# Combination of Uncertainty Terms

# Additional ACM Blind Benchmark Results

# Comparison of Hammer Test to FEA Predictions

# Steam Dryer Load Extrapolation

# Additional ACM Blind Benchmark

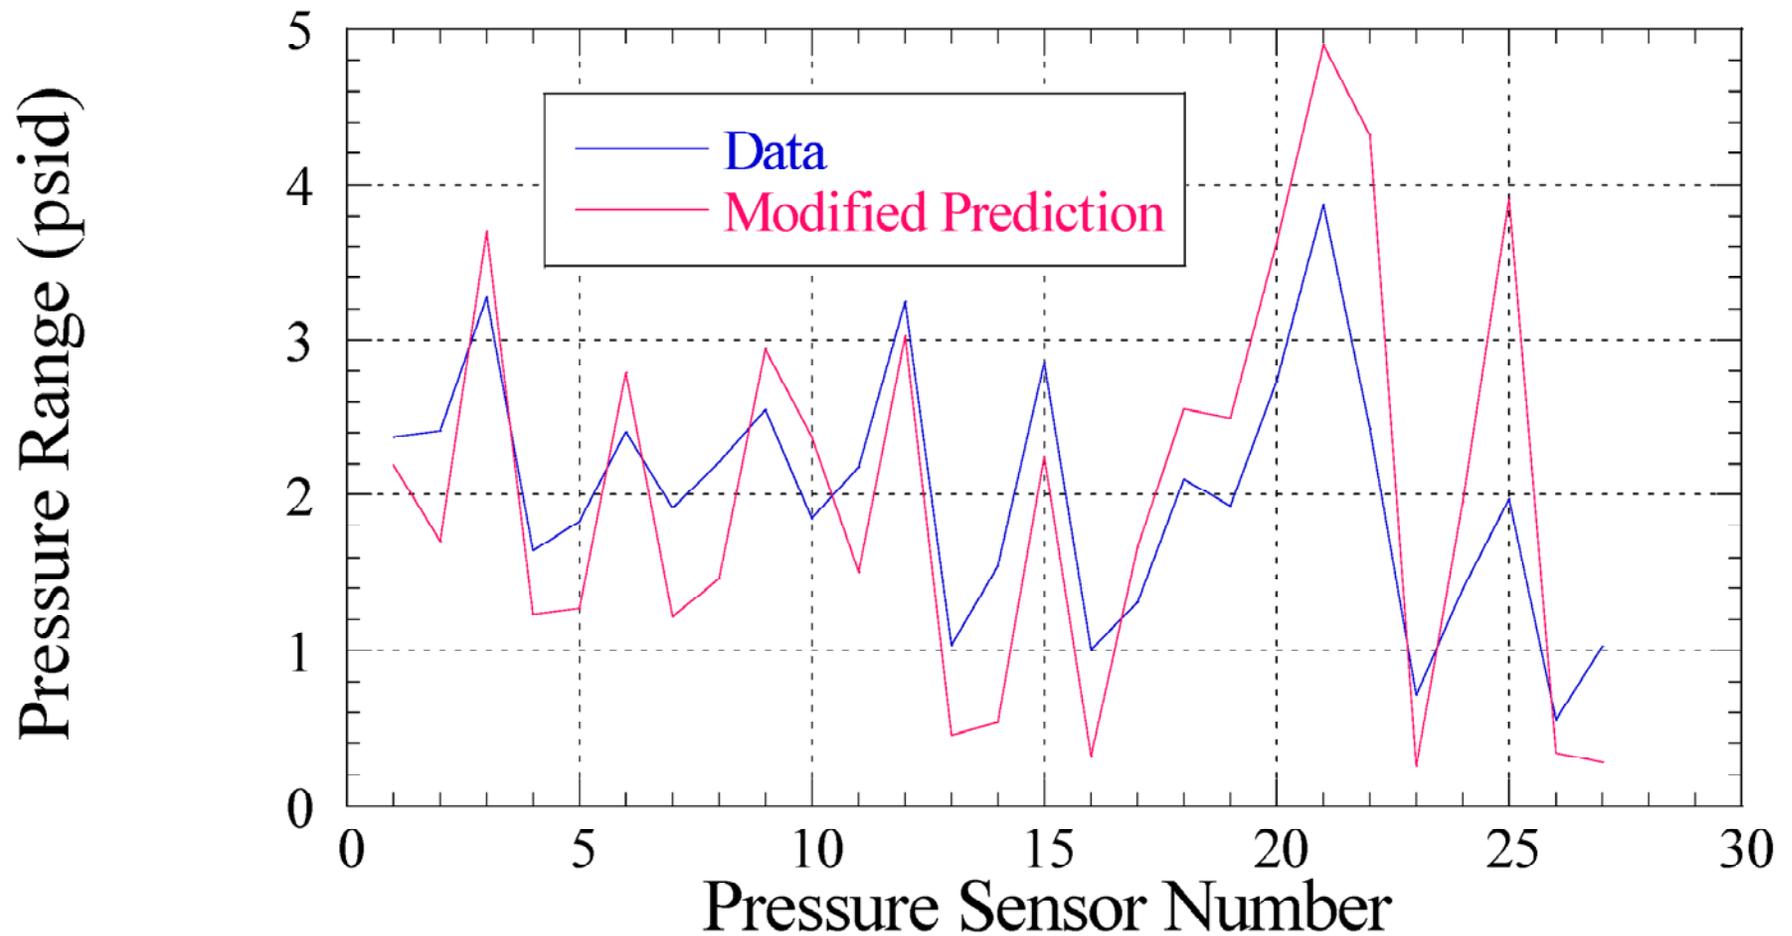
- Prove that the Modified 930 ACM will accurately predict loads for other cases/reactors.

- Continuum Dynamics, Inc. (CDI) performed blind benchmark tests at 790 megawatts-electric (MWe) and 930 MWe to demonstrate the accuracy of the ACM
- CDI made adjustments to the model following each benchmark
- To demonstrate that final adjustments to the Modified 930 MWe ACM were appropriate for use at all other power levels, CDI performed a third blind benchmark at 912 MWe
